SERVICE BULLETIN

SB14-0007

SUBJECT: 4A2301-01 (RS64C1E-CAZ) COMPRESSOR CHANGE (50 CYCLE)

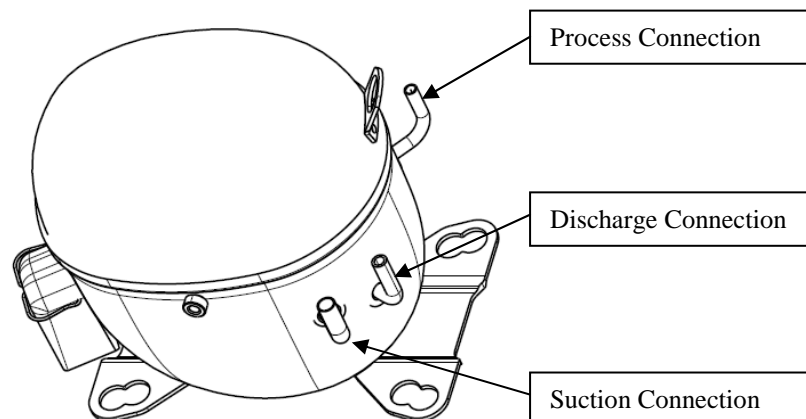
Although the footprint and the mounting of the compressors will be the same, this change may require connecting different size tubing, using standard refrigeration practices and lengthening of the compressor leads during change out. The process tube and discharge connection went from 3/8" I.D. to 1/4" I.D. tubing. The suction connection went from 1/2" I.D. to 3/8" I.D. See below for location of the ports on the replacement compressor.
